BID ADDENDUM 01

Bid Addendum #1

Orange-Ulster BOCES Interior Alterations - Third Floor Regional Education Center at Arden Hill

DEMOLITION

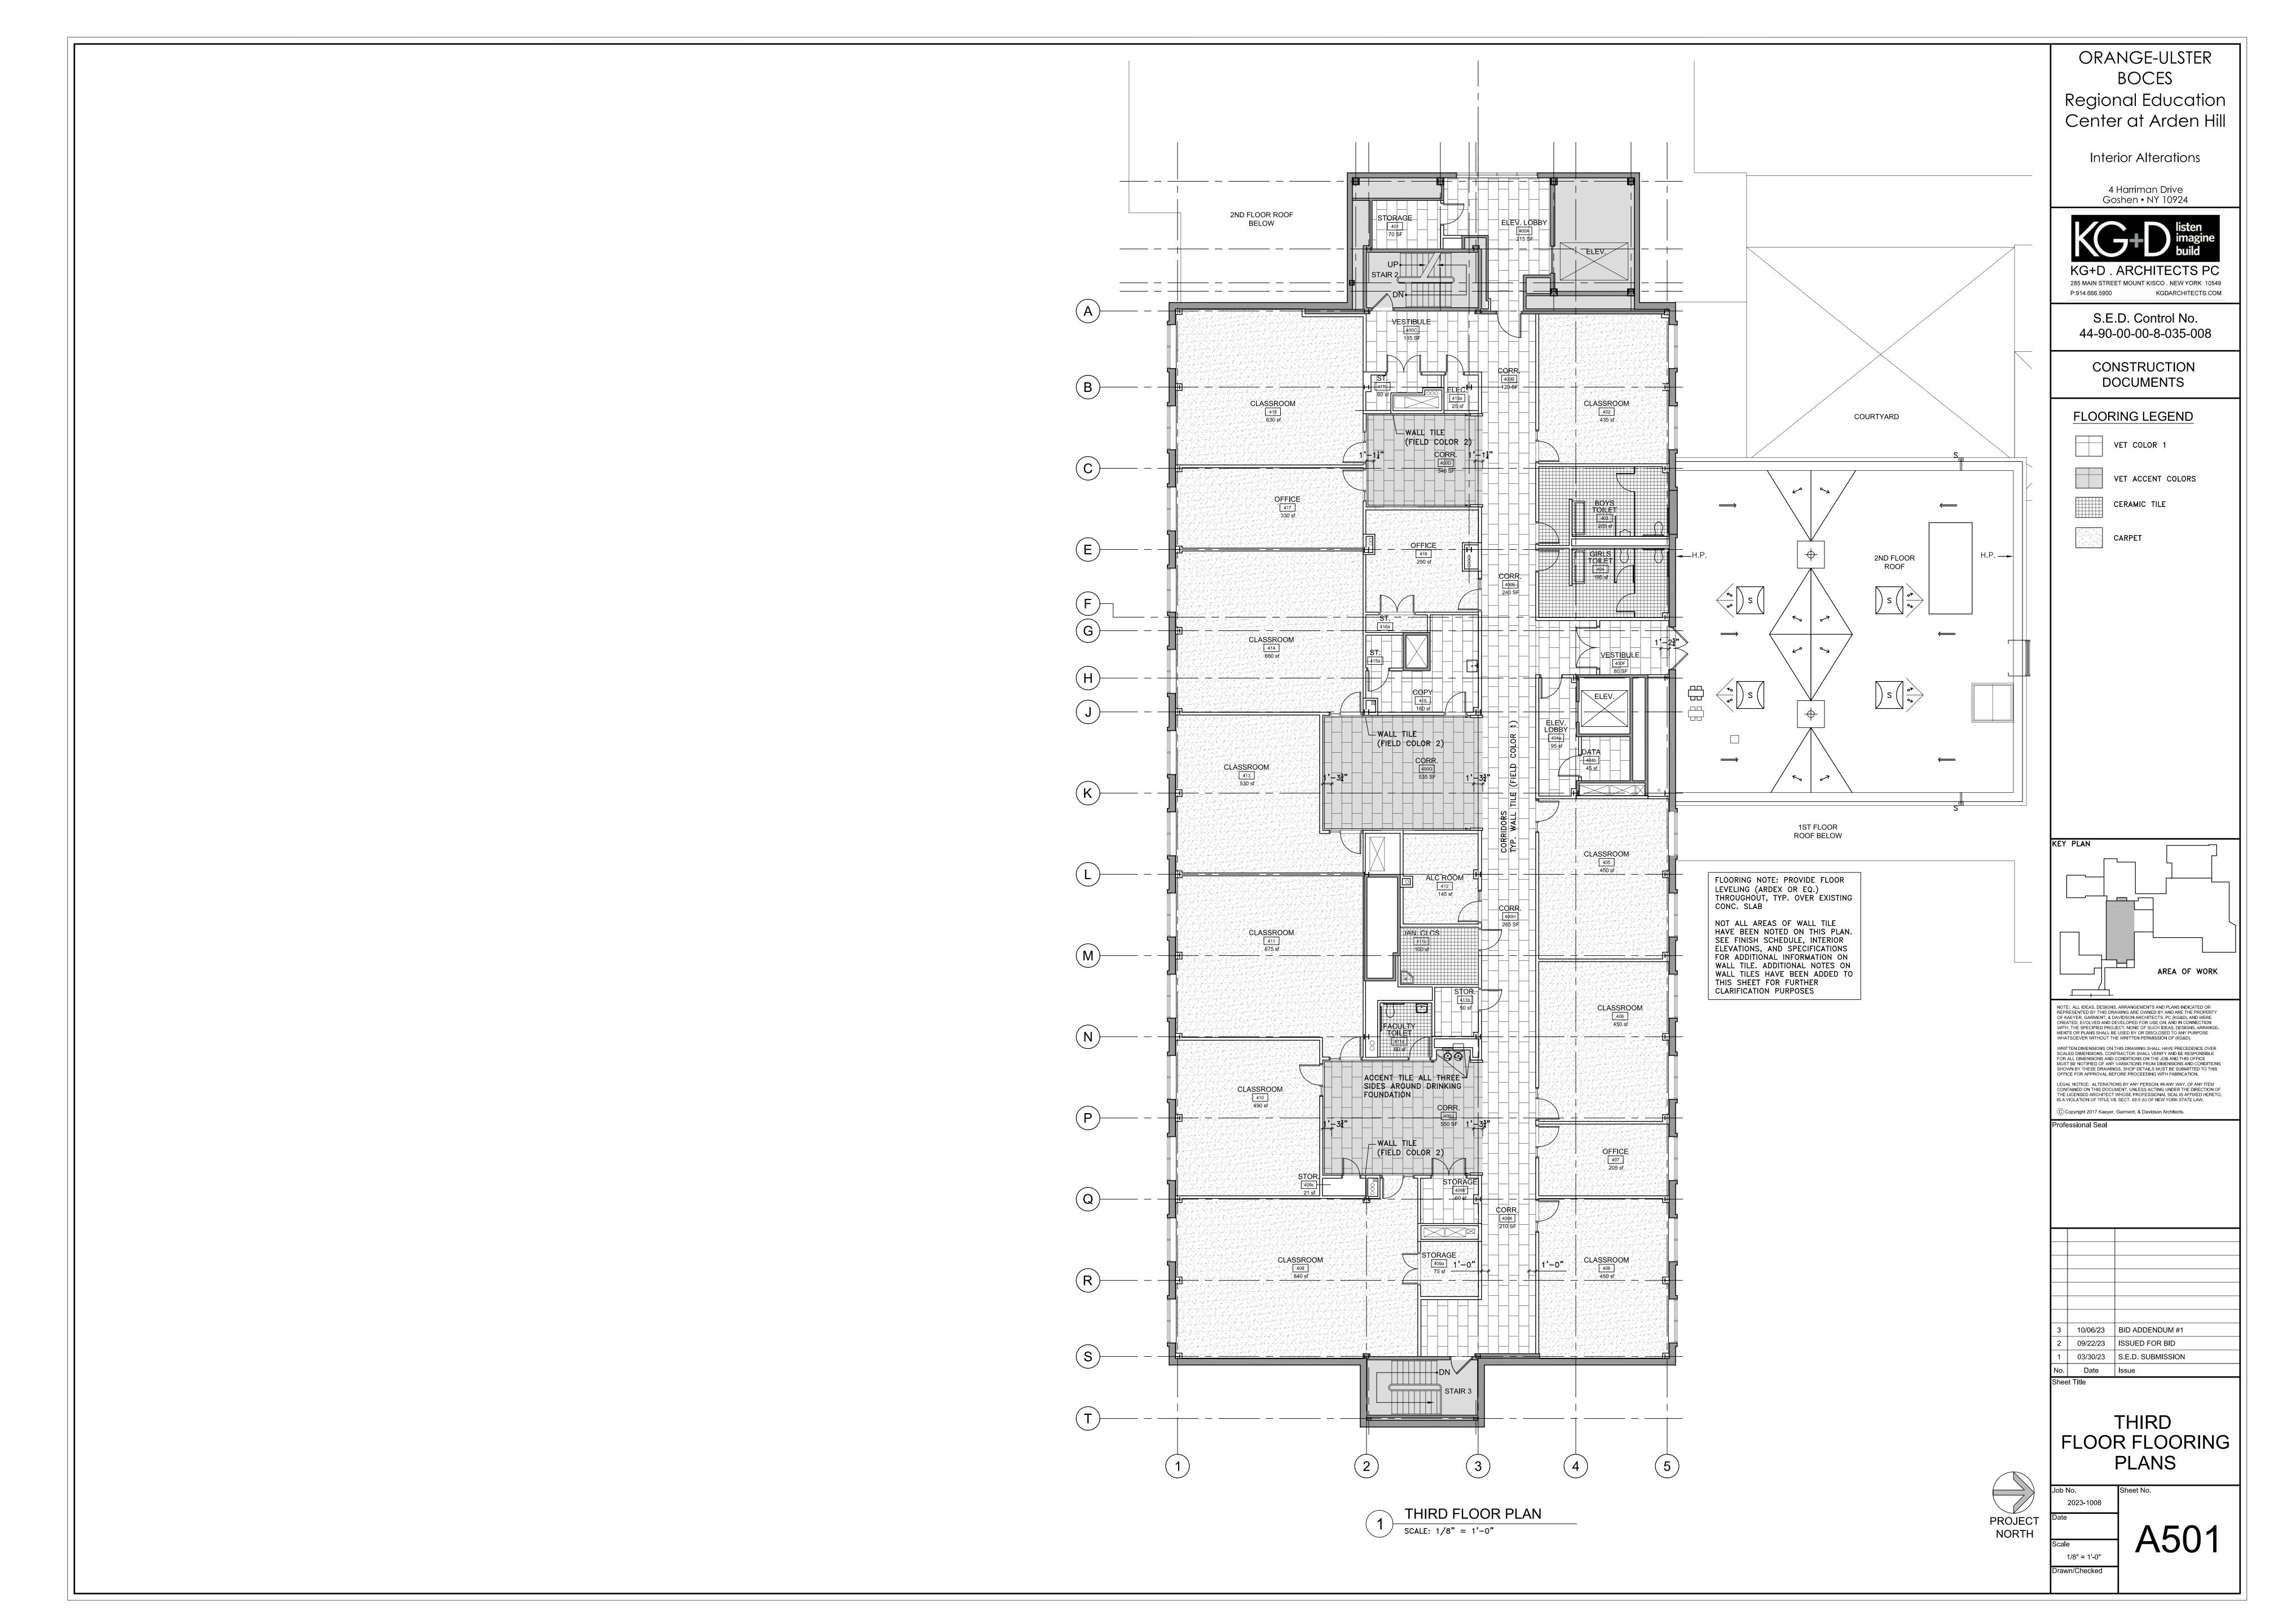
- 4.1 DRAWING A101 See attached REVISED A101 with information on the existing structural framing added for reference purposes.
- 4.2 DRAWING A501 See attached REVISED A501 with VET (Vinyl Enhanced Composition Tile) pattern showing 18x36 sized tiles in brick ashlar pattern to match description in Specifications Section 096500

- 7.1 RFI Question Is the structural framing plan forthcoming?

Response Drawing A101 shows dashed lines (see demolition legend) indicating the layout of the structural steel framing. See attached REVISED A101 with additional information added pertaining to the existing structural framing for reference purposes.
- 7.2 RFI Question Is the existing steel primed? If the steel is primed, please provide data sheet to confirm the compatibility of the primer with sprayed fire-resistive materials.

Proposed Access, Material, Parking Storage Plan – OUBoces Arden Hill

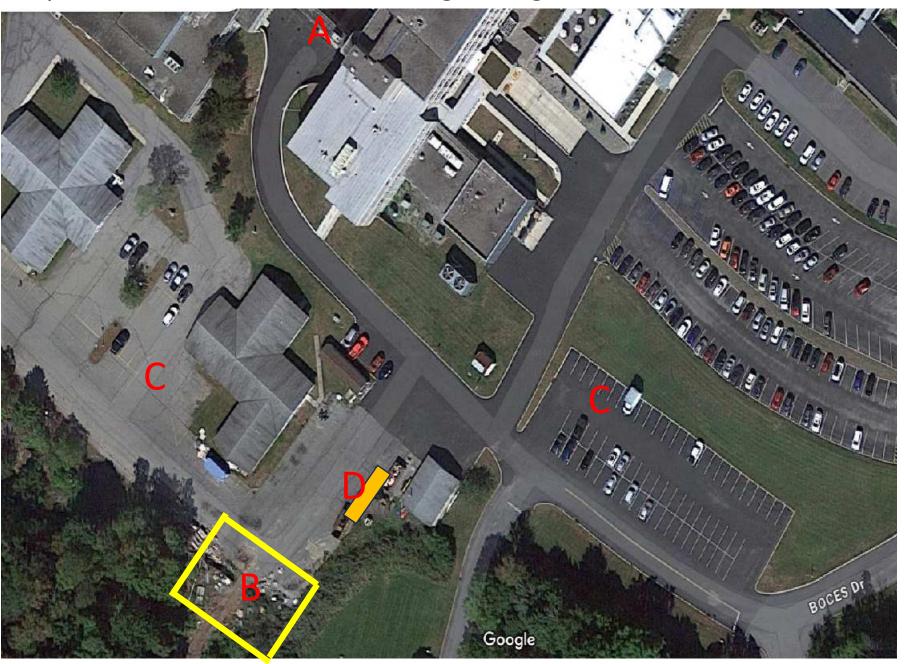
- 7.6 RFI Question Sheet PH-1 General Phasing, Staging, & Egress/Access Notes reference temp fencing @ staging/laydown area. This area is not shown on drawings please clarify area to be fenced off or approximate length of temp fencing required.

- 7.18 RFI Question Please provide a location for the dumpsters.Response Dumpsters may be located adjacent to storage area. Refer to Staging Plan.
- 7.19 RFI Question Drawings indicate work on the ground floor, 1st floor, & 2nd floor. Will this work need to be done at off hours? Will contractors have complete access to those rooms? Response These are occupied spaces during the school year. Access will be provided and coordinated during off shift hours.

Response Refer to attached staging plan. Area of storage is approximately 60'x80'
- 7.7 RFI Question Sheet PH-1 General Phasing, Staging, & Egress/Access Notes references Temporary Barriers to include HM doors/frames. These Temp Barriers are not shown on drawings please advise.

If laydown area is desired, approx. 60x80 space is designated for GC to use, fenced in if not using containers for security. This area already has been cleared and base stone installed
